**GWF POWER SYSTEMS**

**RE: Comments on Tentative NPDES Permit No. CA 0082309  
GWF Power Systems, Site 4**

**ATTACHMENT B – MAP**

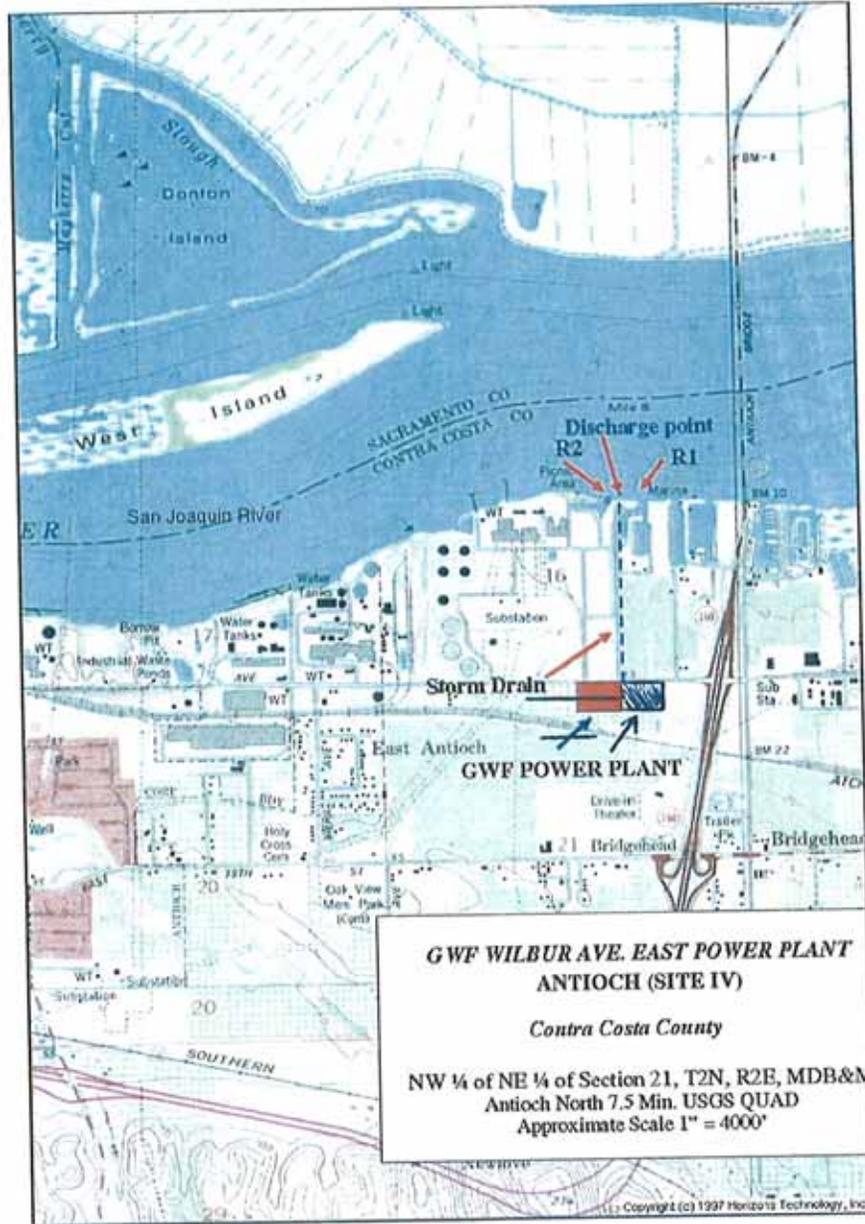
Move the facility location to the East side of the storm drain as indicated on the map by the new arrow. Please note the strikethrough on the facility and arrow of the original location to be deleted
